Final Acceptance Punchlist
El Paso County – Department of Public Works - Stormwater Section

Project Name:	Hannah Ridge F7
EDARP Filing Number(s):	CON1932, SF1840
ESQCP Number:	ESQ1926
Attendees:	DPW SW: Dylan Finley DPW Development Services: Brad Walters, Spencer Pirzadeh Developer: Adam Doyle
Date of Walk-Thru:	10/12/2023
Walk-Thru Number:	1

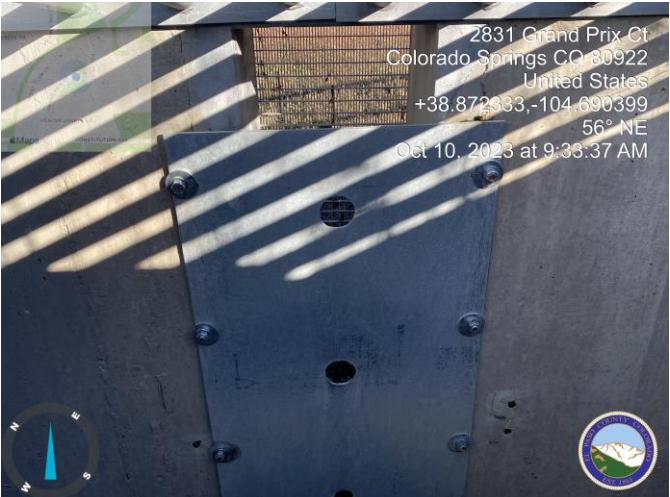
<p>Photo 1: The orifice plate was installed such that there is a vertical orifice at the top of it that is not accounted for in the UD-Detention spreadsheet. Update calculations or field condition.</p>	<p>Photo 2: Micropool is over capacity. No longer functioning as designed. Remove sediment and debris to allow adequate drainage flow.</p>
